Access Compliance Report

Public Rights-of-Way

Intersection ID: 18144	Main Street: BRANDYWINE_RD	Cross Street: WESTFIELD_RD	Location: NW
ADA ID: 74D22FA78EDB	Ramp Type: PerpDiag	Initial Pass/Fail: Fail	Overall Compliance: No
		Severity Score: 10

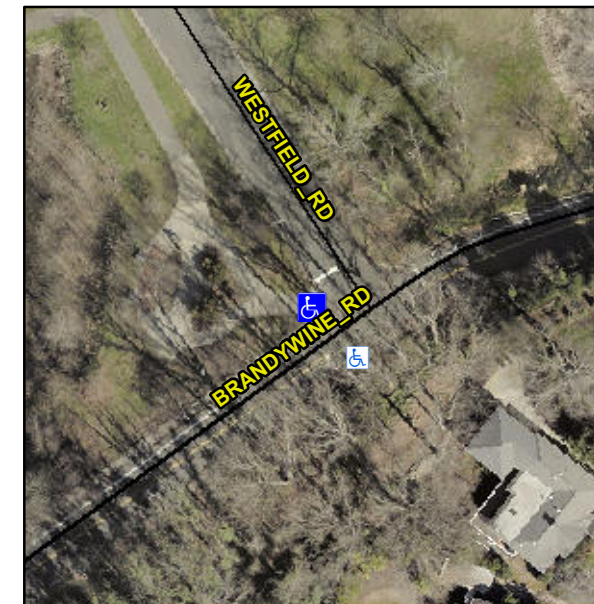
Not Found, R304.5.1, R304.5.3

Compliance	Description	Data	Compliance	Description	Data
N/A	Ramp Length (in)	43.0	Yes	Ramp Slope (%)	8.0
No	Ramp Width (in)	47.0	No	Ramp XSlope (%)	2.2
N/A	Flare Type LT	N/A	N/A	Flare Type RT	N/A
N/A	Flare Slope LT (%)	N/A	N/A	Flare Slope RT (%)	N/A
N/A	Flare Traversable LT?	N/A	N/A	Flare Traversable RT?	N/A
N/A	Landing Length (in)	N/A	N/A	DWS Provided?	N/A
N/A	Landing Width (in)	N/A	N/A	DWS Contrast?	N/A
N/A	Landing Slope (%)	N/A	N/A	DWS Length (in)	N/A
N/A	Landing X Slope (%)	N/A	N/A	DWS Full Width?	N/A
N/A	Landing Curb? (Y/N)	N/A	N/A	DWS Offset (in)	N/A
N/A	Shared Landing?	N/A			
N/A	Gutter Ponding?	N/A	N/A	Gutter Slope (%)	N/A
N/A	Gutter Lip Ht (in)	N/A	N/A	Gutter X Slope (%)	N/A
N/A	Painted X Walk1?	No	N/A	Painted X Walk2?	No
	X Walk 1 Direction	To SE		X Walk 2 Direction	To NE
N/A	X Walk 1 Width (in)	N/A	N/A	X Walk 2 Width (in)	N/A
	X Walk 1 Slope (%)	5.2		X Walk 2 Slope (%)	7.0
	X Walk 1 X Slope (%)	5.6		X Walk 2 X Slope (%)	5.2

Remove & Replace Curb Ramp With Two New Directional Ramps or Equivalent.
